SERVICE INFORMATION LETTER NO. T-030

1. SUBJECT: Main Rotor Gearbox Bolt Retorque

2. MODEL: TH-28, 480, and 480B

Figure 1. Main Rotor Gearbox Attachment Bolts

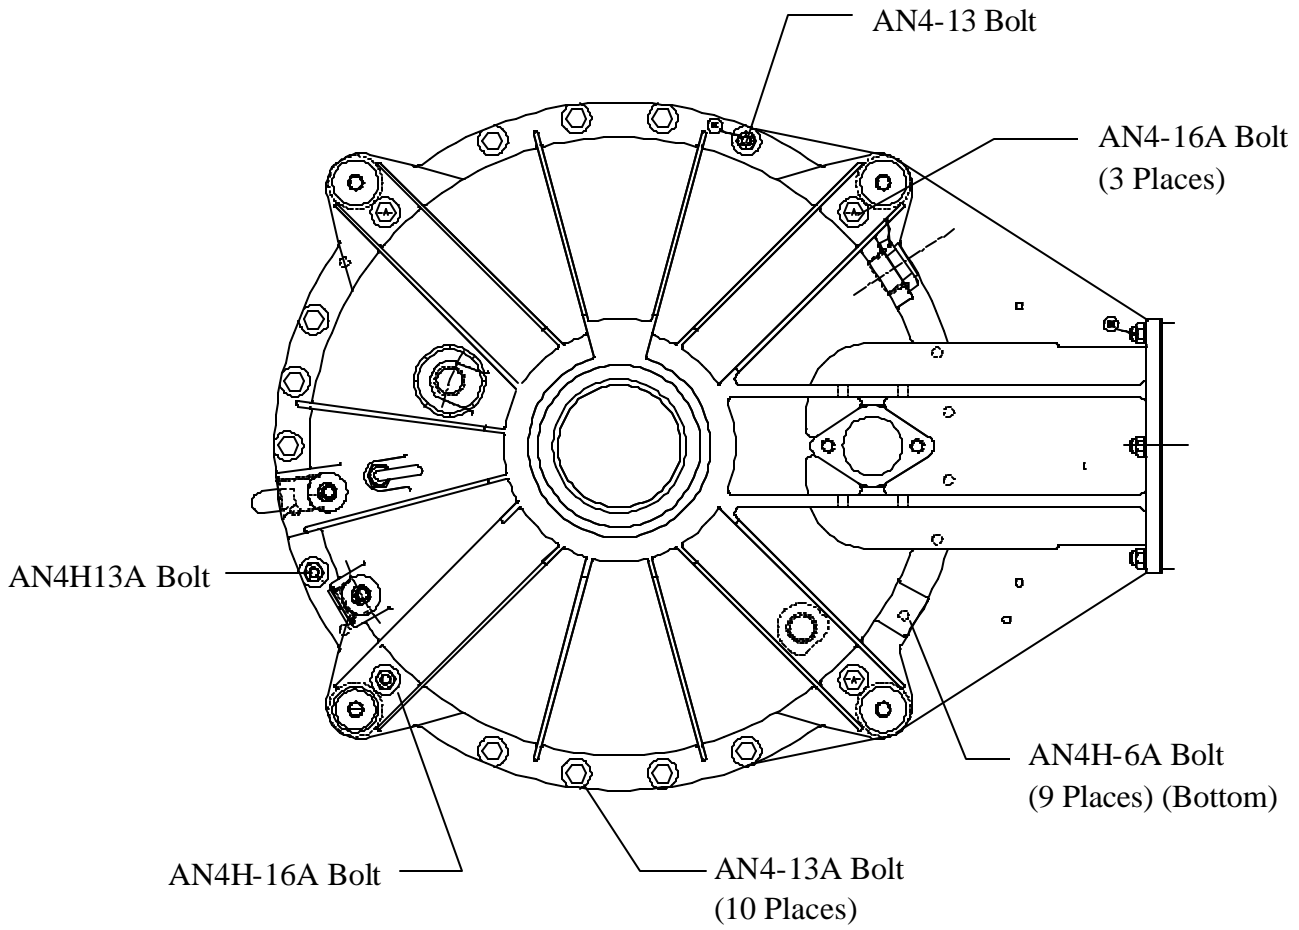
- A. Locate the main rotor gearbox bottom cover attachment bolts (reference Figure 1).
 - B. Remove safety wire.
 - C. Remove lead seal as required and note on the component record card that the SIL was complied with and the lead seal was removed.
 - D. Retorque each referenced nut and bolt to 100 in-lb.
 - E. Safety wire bolts.
 - F. If the torque has not changed, no further action is required.
 - G. If the torque has changed, retorque again at the next scheduled inspection.
- 5.2. PARTS: MS20995-C32 Safety Wire, As required.
6. SPECIAL TOOLS: None
7. MAN-HOURS: 2-4 Man-hours
8. WARRANTY: Per Enstrom New Helicopter Warranty policy.
9. WEIGHT CHANGE: None
10. LOG BOOK ENTRY: As required for maintenance actions.
11. REPETITIVE ACTION: See 5.1.G.
